Neils report on
voice mod. for TA-1.

General: TA-1 Transmitter
 Specific: Modulator (Project 2515)

FIG. I
PRESENT CIRCUIT OF TA-1 MODULATOR

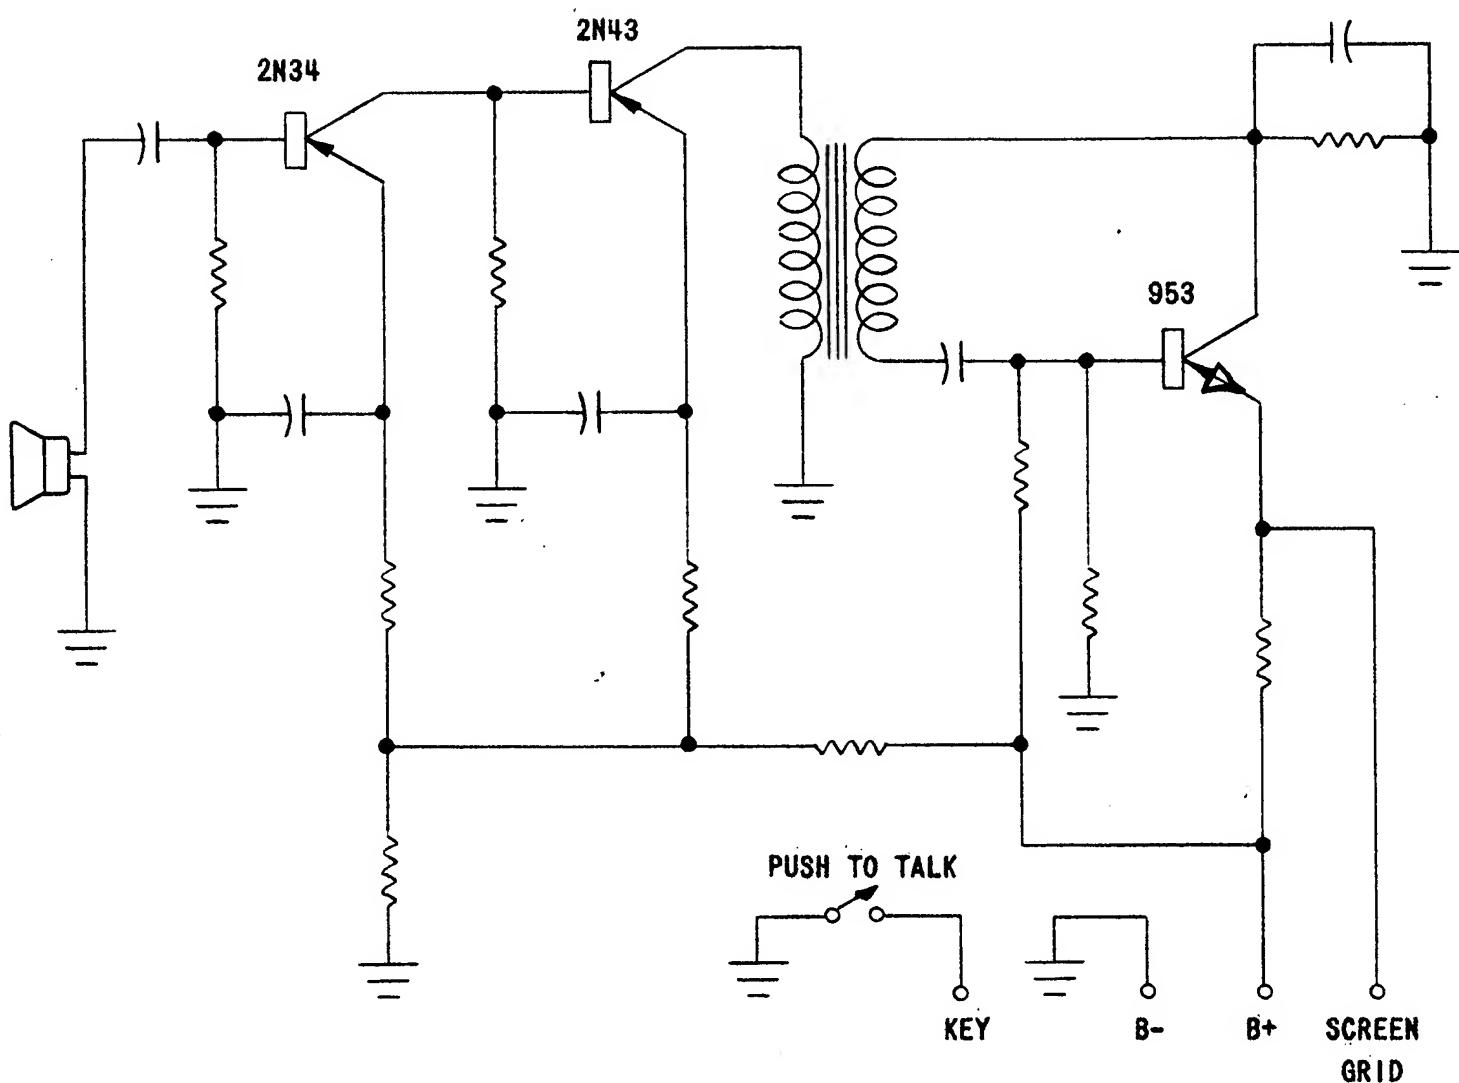
TRANSMITTAL SLIP		DATE March 18/57
TO: <i>Neil</i>		
ROOM NO.	BUILDING	
REMARKS: <i>Neil please comment on Para 2 of your report How can we correct or get around this situation.</i>		
<i>ATB</i>		
<i>Please return</i>		
FROM:		
ROOM NO.	BUILDING	EXTENSION

Figure 1 in the appendix shows the circuit developed. This circuit performed satisfactorily but has one serious fault. If the transmitter tube is removed or the filament opens, the transistor (953) might be damaged due to the increase in collector voltage.

The more satisfactory way to modulate the transmitter is to create a separate modulator unit. A separate unit creates no hazard to the final transistor; its installation is simple enough so that a field station could adapt it to existing TA-1 transmitters.

FIG. 2
PROPOSED CIRCUIT FOR TA-1 MODULATOR

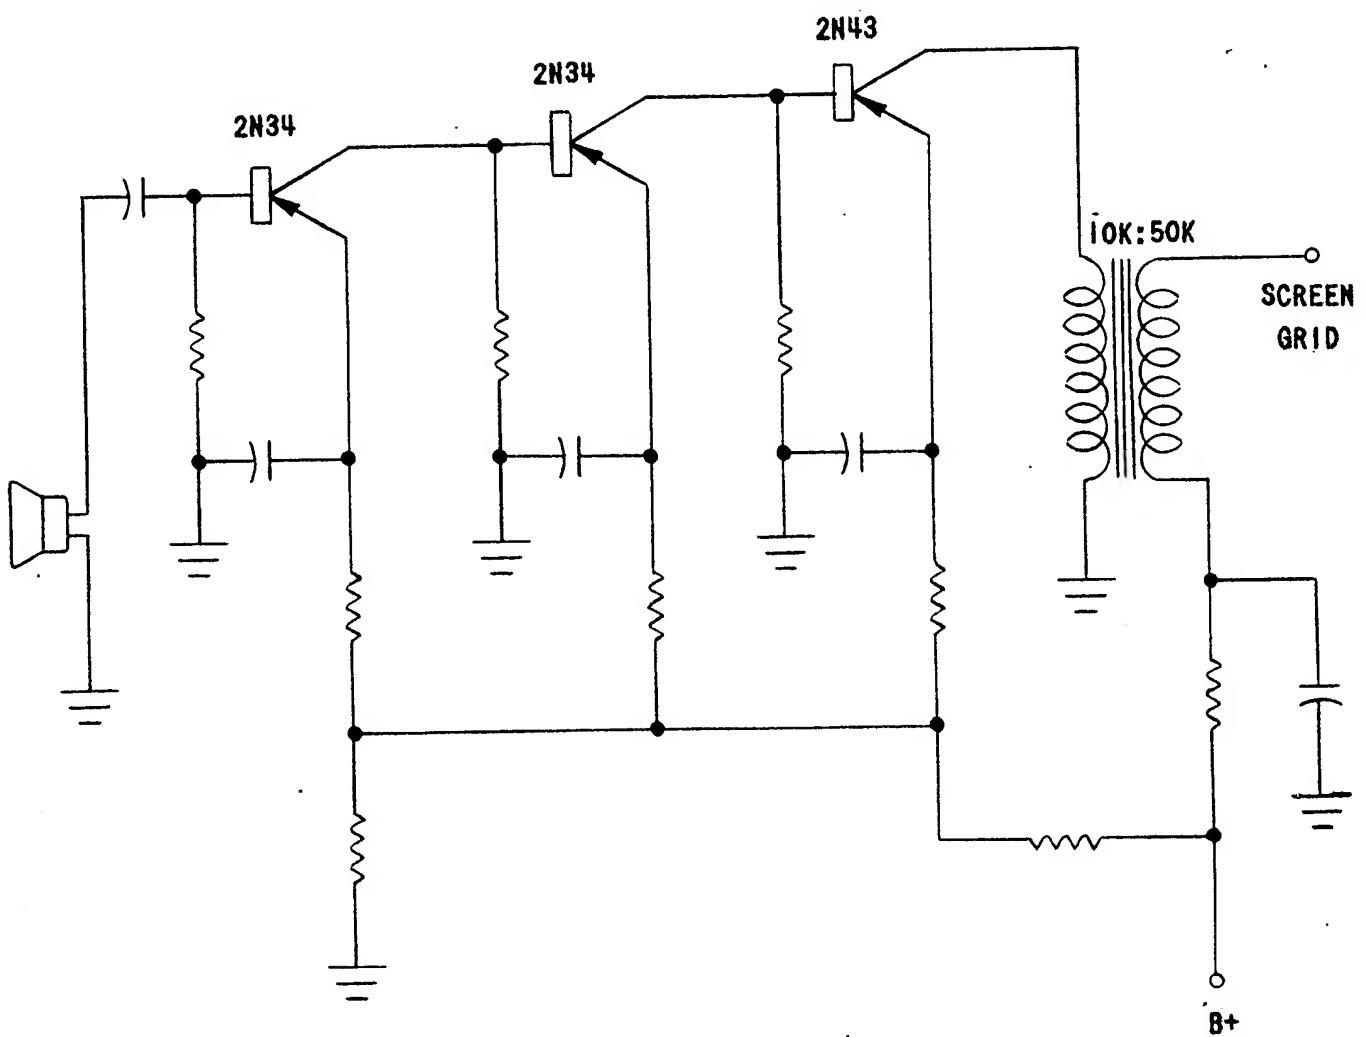
The modulator may be made as a separate unit. The circuit shown in Figure 2 should modulate the transmitter 60 to 75 percent. Two power cables would be necessary. One cable would be used for [redacted] and the other cable for phone operation. Modifications on TA-1 transmitters now in the field could be made without any difficulty. A separate modulator unit would not appreciably increase the weight or size of the completed unit.
